City of Portland, Maine – Building or Use Permit Application 389 Congress Street, 04101, Tel: (207) 874-8703, FAX: 874-8716

DATE: 2 June 97 ADDRESS: 13 June St.
REASON FOR PERMIT: To rebuilt deck in same footprint
BUILDING OWNER: Gardner, K & T.
CONTRACTOR: owner
PERMIT APPLICANT: X/1 X7 X9 APPROVAL: X/17 X9 ~~DENIED~~

BASIC GUIDELINES FOR DECK PERMITS

13 JUNE STREET
PORTLAND, MAINE

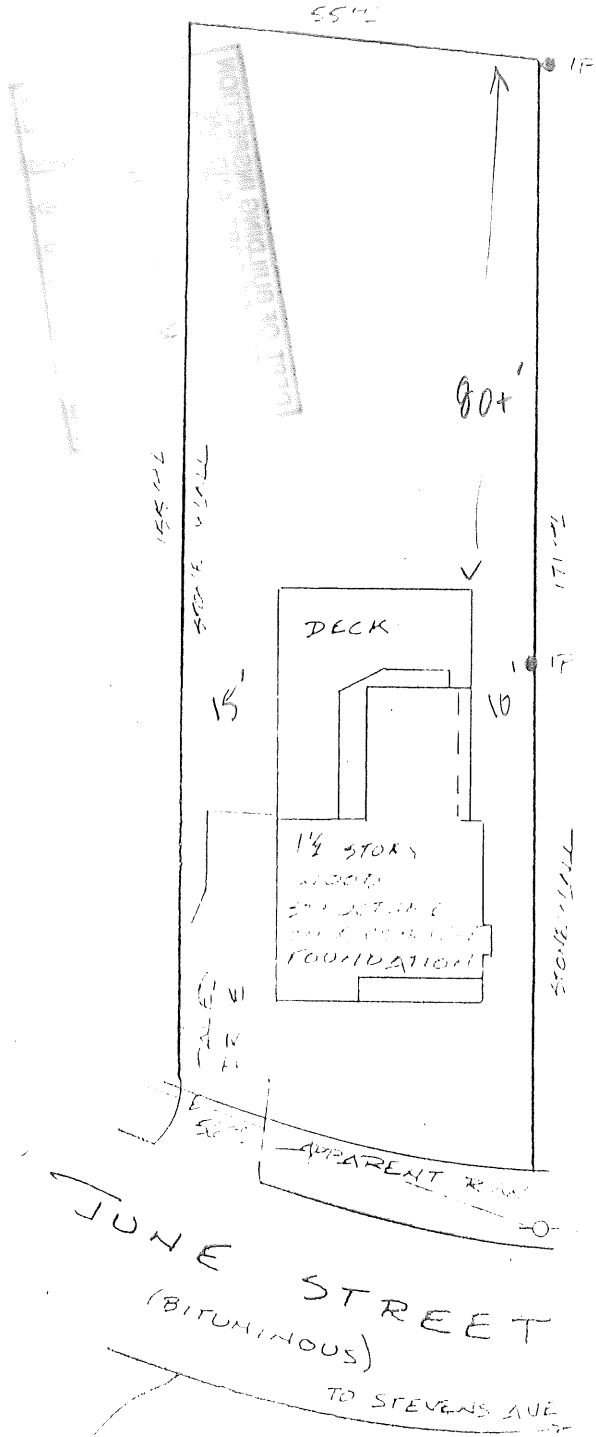
Note: 25' rear req -
8' on sides req.
OK
